**RESIDENTIAL SITE PLAN APPLICATION** (townhouses, apts., etc.)  
**City of Rochester, New Hampshire**

RE: Proposed Site Plan (16 Units)  
Land off Flack Rock Bridge Road  
Rochester, NH  
Owner: Knox Marsh Development LLC  
16 Unit Townhouse Style Development  
Non-Chapter 218 Waiver Requests

Re: TRG #II Response  
Knox Marsh Development, LLC  
Flat Rock Bridge Road  
Tax Map 210, Lot 64

Re: Third Party Drainage Review Response #1  
Knox Marsh Development, LLC  
Flat Rock Bridge Road  
Tax Map 210, Lot 64

RAIN GARDEN #3 W/ INFILTRATION  
LAND OF KNOX MARSH DEVELOPMENT LLC  
FLAT ROCK BRIDGE ROAD  
ROCHESTER, N.H.  
74x MAP #10, LOT 64

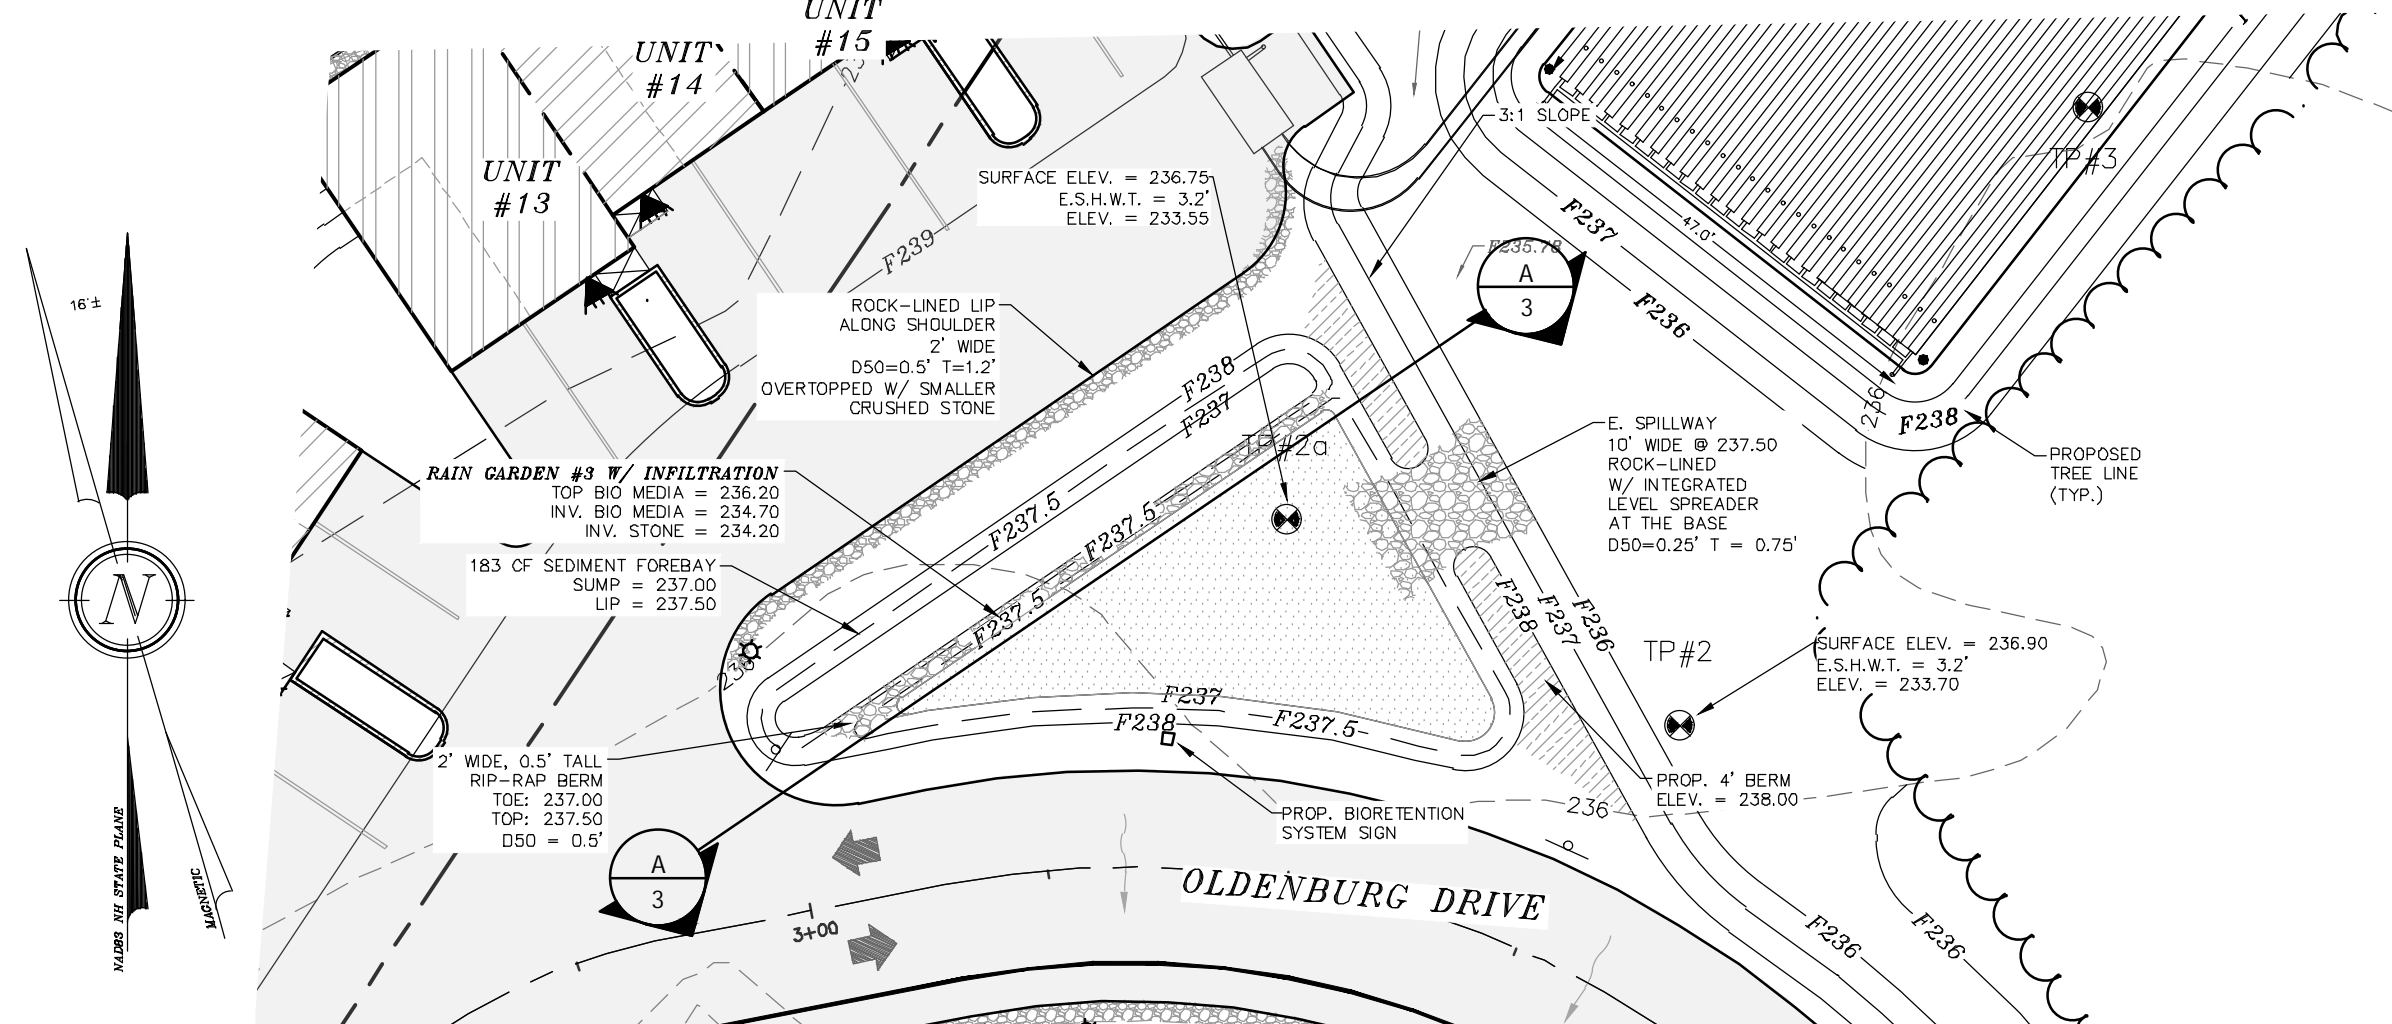
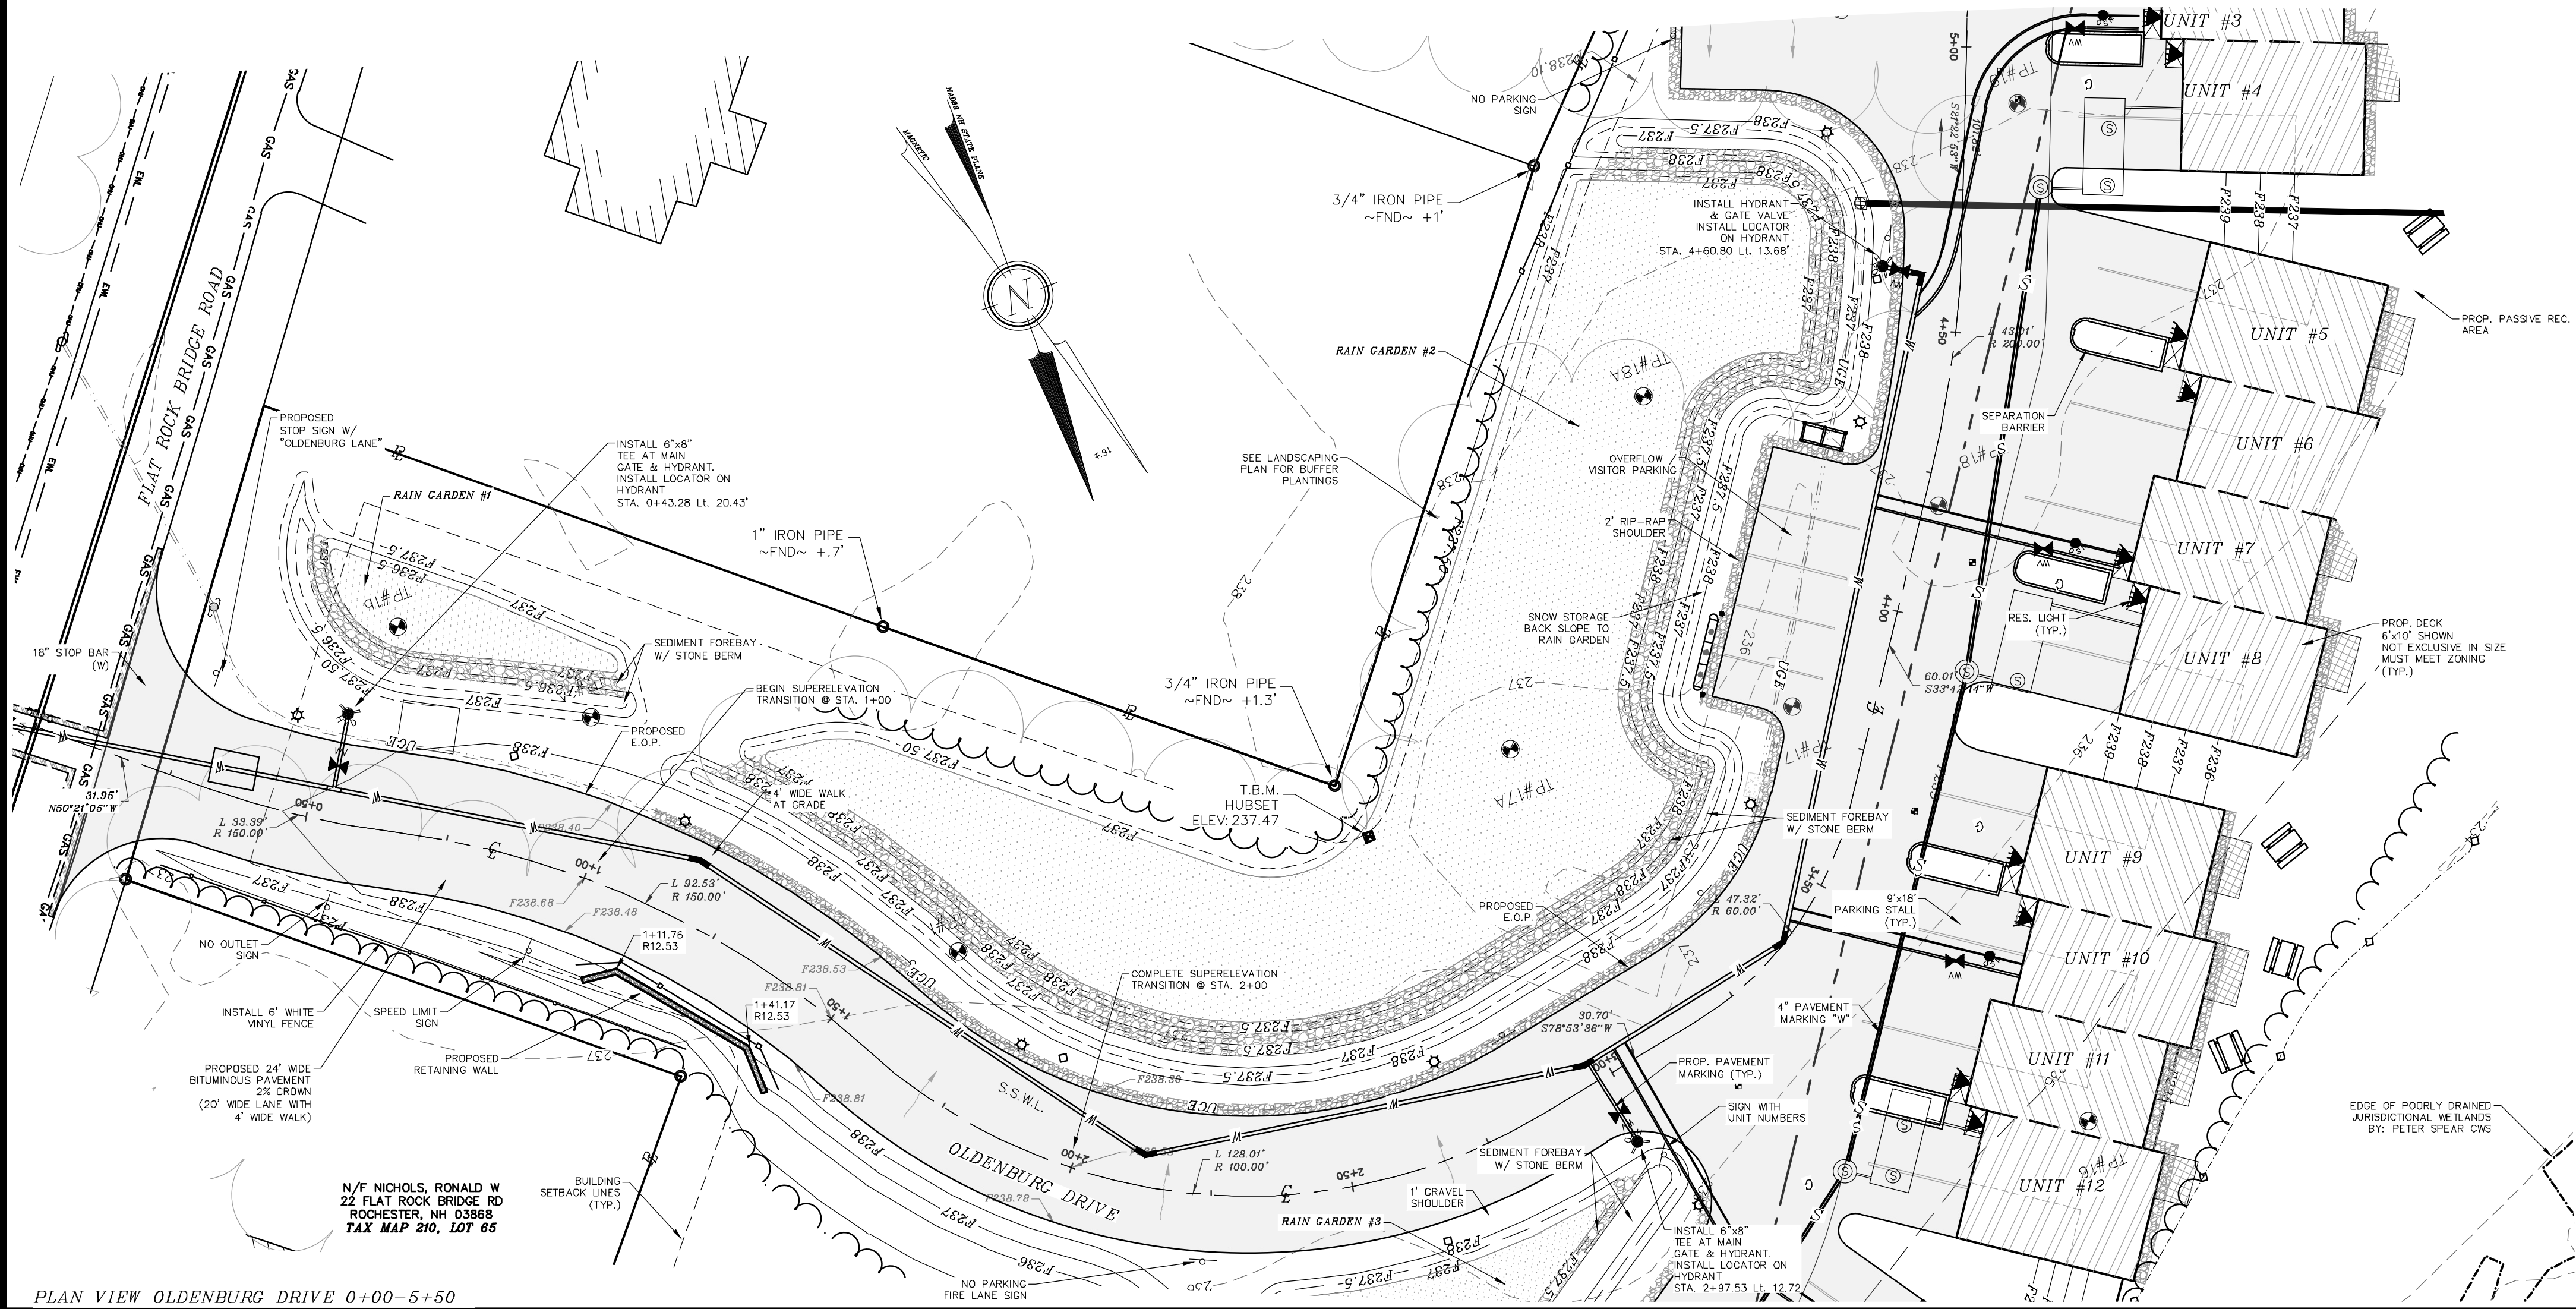
- c. *The rain garden details on Sheet 8 should be updated to show the elevation of the top of aged bark mulch and depth of open storage.*

- d. *The proposed rain gardens include perimeter plantings (trees) as well as shrubs and perennials on the surface. The maintenance of the rain garden is imperative to ensure that these will infiltrate as designed. The applicant should consider proposing a surface that would be easy to maintain (i.e., grass). With the current*

*planting plan the accumulation of leaves from perimeter trees, trash and debris, sediment, potential establishment of trees and shrubs may inhibit capacity and infiltration of the proposed practice. The Applicant has modeled the raingarden with "open storage"; however, once the proposed plants are mature, they will reduce the amount of open storage in the raingarden. If the Applicant chooses to keep the planting plan as shown, they should modify the open storage to reflect the mature vegetated condition.*

**Please find revised Rain Garden Details on sheets #8-10. The bark has been removed and replaced with grass.**

**The applicant has opted to remove the vegetation and plant the rain gardens with grass. Please find Rain Garden Plans, Sheets #8-10.**

SHEET 15 OF 29

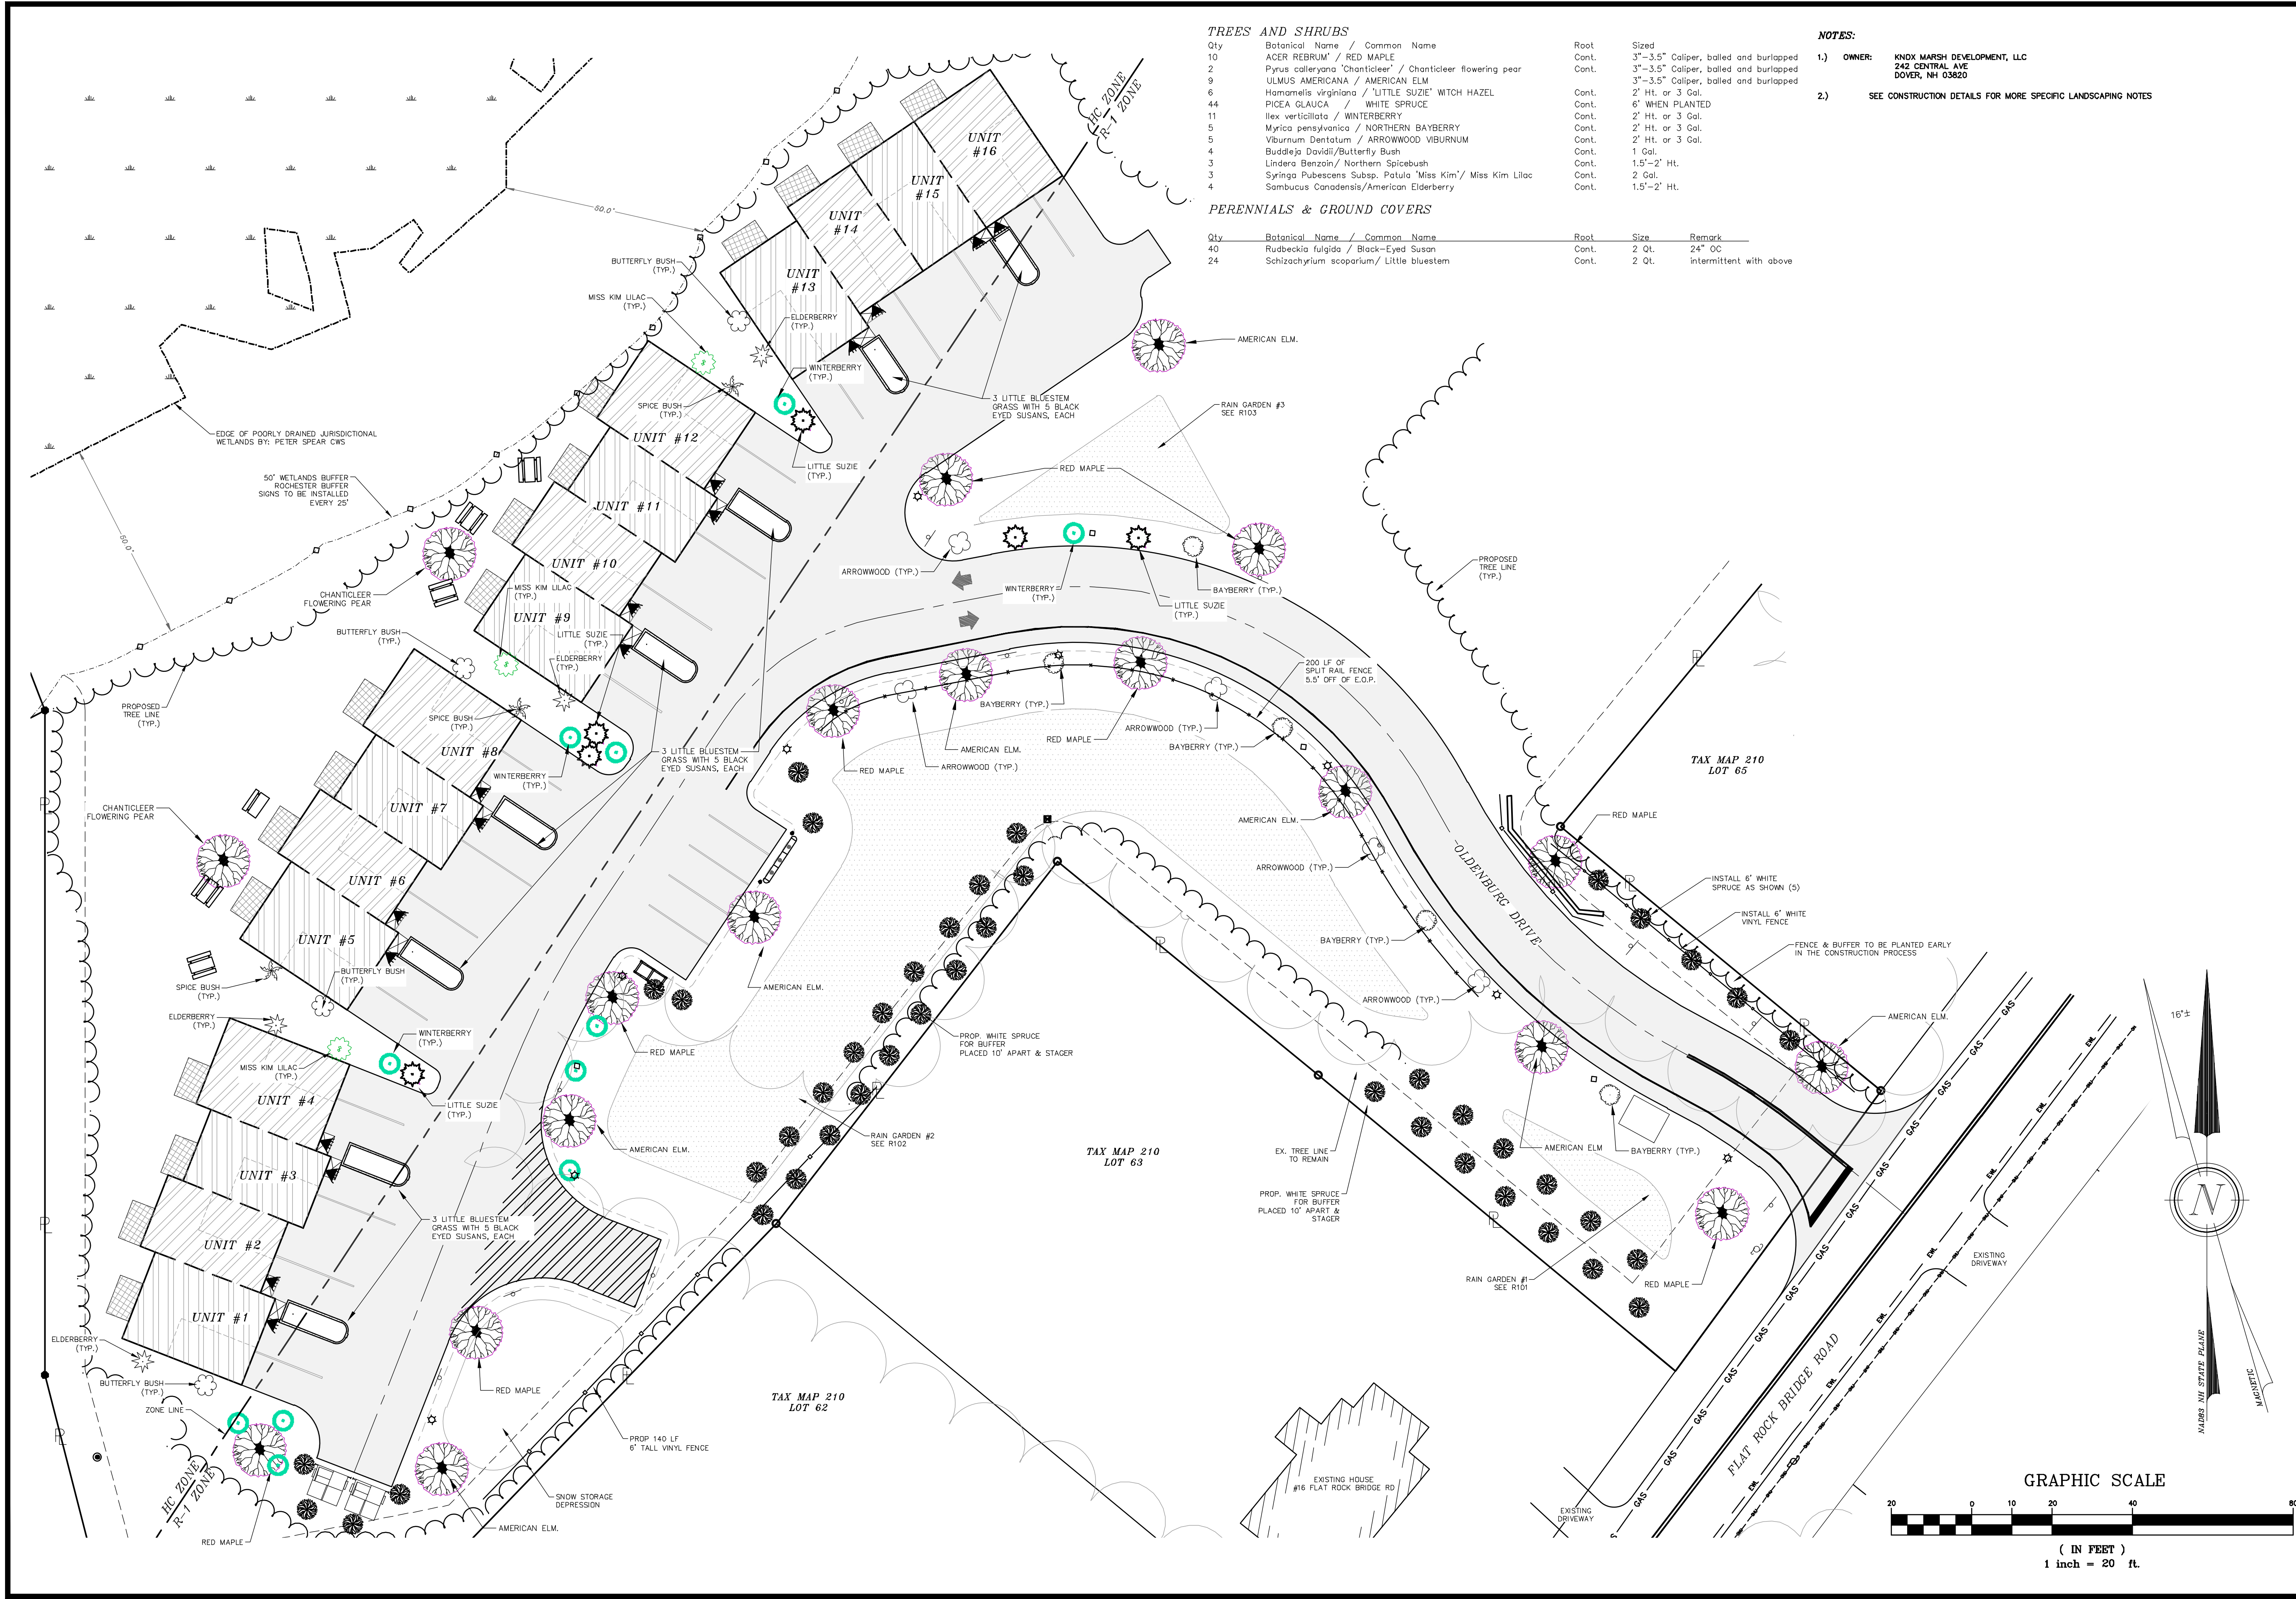
*\*Overall landscaping appears sparse. Recommend increasing the number of shrubs and perennials, especially adding additional plantings between the buildings.*

*\*Would like to see the following plants replaced with New England native species: dwarf fothergilla, Greenwave yew and Feather Reed Cross Karl Feorster.*

*Replace Greenwave yew with New England native, such as Common Juniper (Juniperus communis); Winterberry (Ilex verticillata); Eastern Red Cedar (Juniperus virginiana).*

*Replace dwarf fothergilla with New England native, such as witch hazel (Hamamelis virginiana).*

*Replace Feather Reed Cross Karl Feorster with New England native ornamental grass, such as Little Bluestem (Schizachyrium scoparium) or Switchgrass (Panicum virgatum).*

*We acknowledge the change to include planter islands in front of the units. Thank you and please flesh out plant species a bit more. Looking for something aesthetically pleasing for curb appeal and not just checking the box that landscaping is complete.*

**Please find the revised Landscaping Plan, sheet #15. The Landscaping has been bolstered with shrubs added between units and added along the roadway alignment.**

**These plants have been replaced. Please find Landscaping Plans sheet #15.**

**Greenwave yew has been replaced with Winterberry. Please find Landscaping Plan, sheet #15.**

**Dwarf fothergilla has been replaced with "Little Suzie" Witch Hazel. Please find Landscaping Plan, sheet #15.**

**Feather Reed grasses have been replaced with Little Bluestem. Please find Landscaping Plan, sheet #15.**

**Several additional plant species have been added into the Landscaping Plan. This includes additional trees and shrubs placed throughout. Please find the revised Landscaping Plan, sheet #15.**
